# Product Change Notification (PCN)

PCN #: 2E-2026

Date: February 9, 2026

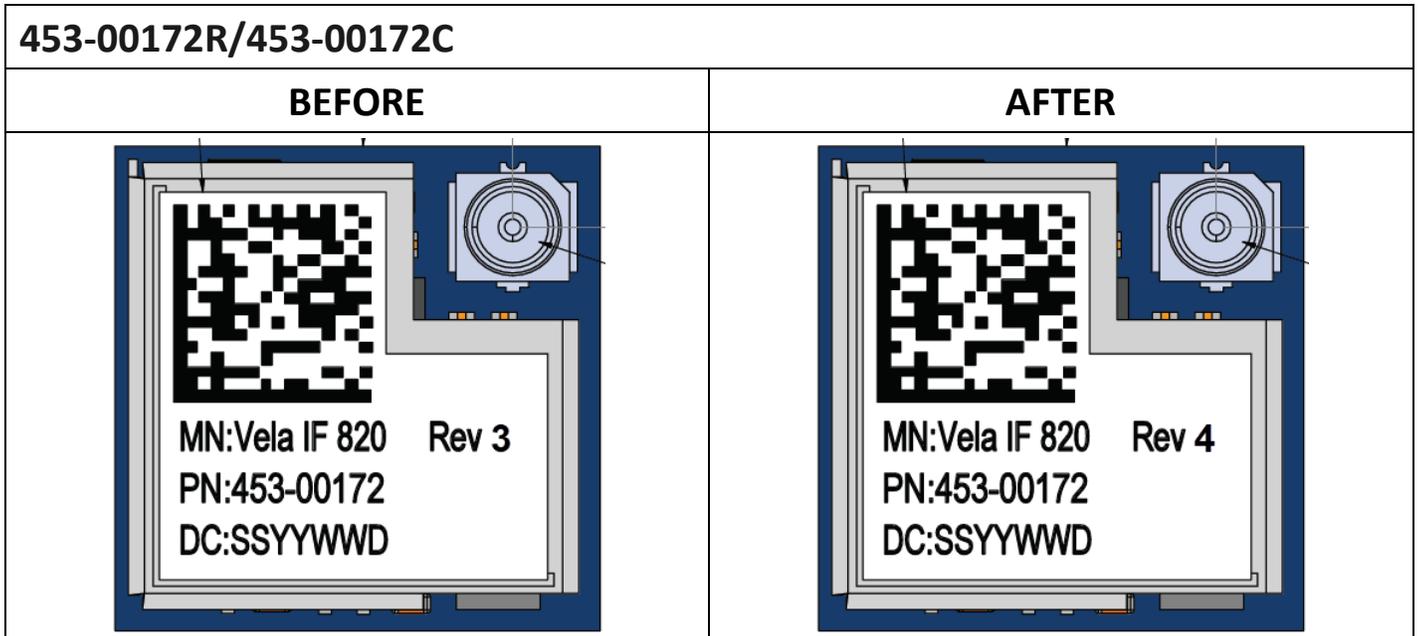
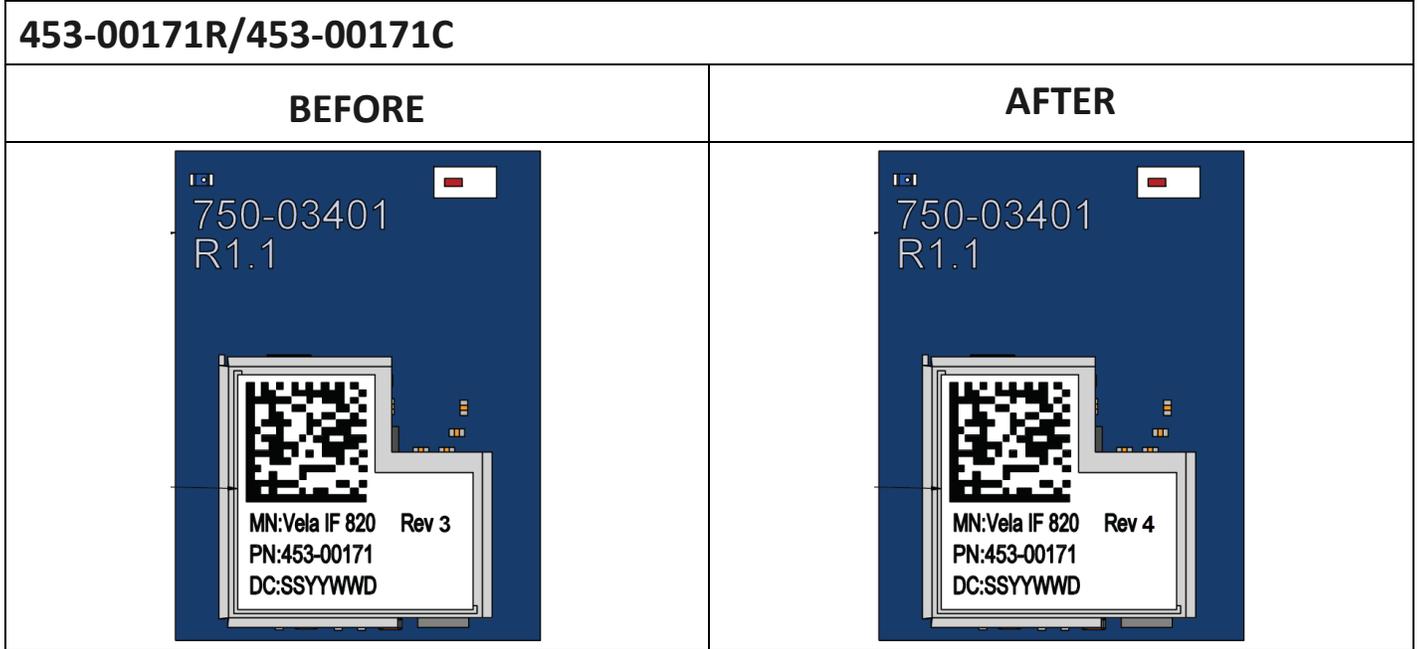
- Firmware loaded to the products in production has been updated from v1.4.16.16 to v1.4.18.18

- Support PUART baud rate greater than 2727272 bps. Baud rate greater than 2727272 bps must use 2 stop bits due to hardware limitation.
- Fix issue: When custom GATT profile has been added, it only works when CYSPP is enabled.
- Fix a lockup issue due in heavy UART loading.

- Protocol Set Parse Mode (SPPM) now defaults to disable auto parse. In order to use binary mode, enable it or enable auto parse with the SPPM command.
- Add support for keyboard paring. Add PKE event and /PE command.
- Implement SBTP,F=1 to disable sniff feature. This improves SPP throughput.
- Add using CYSPP pin to exit SPP MODE (pull CYSPP pin high) and transition back to command mode.
